PRODUCT UPDATE

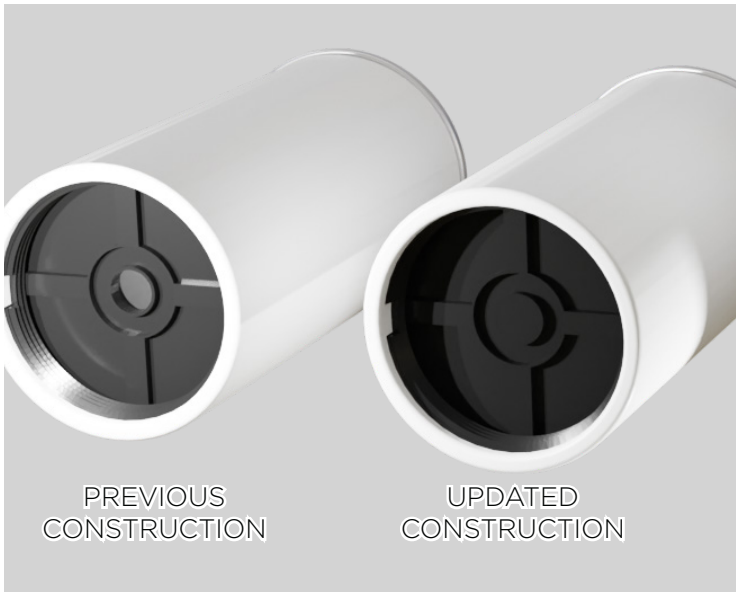
The WIX 33783 fuel filter has undergone a design change. The center hole that was part of the former construction **is no longer required** for the new construction. Filtered water content coalesces on the outside of the media and drains down the side of the filter into the bowl to be drained as necessary.

The indexed indentations visible in the seamed area of the can are the result of the use of an alternate baseplate construction. The shape of this baseplate prevents the can from rotating independently of the threaded plate once the two are seamed. The process used to make this geometry also reduces overall metal waste which supports environmental waste reduction efforts. When seamed, the filter can conforms to the shape of the baseplate resulting in the indentations identified in the illustration. The indentations **should not be confused with dents or damaged seams.**
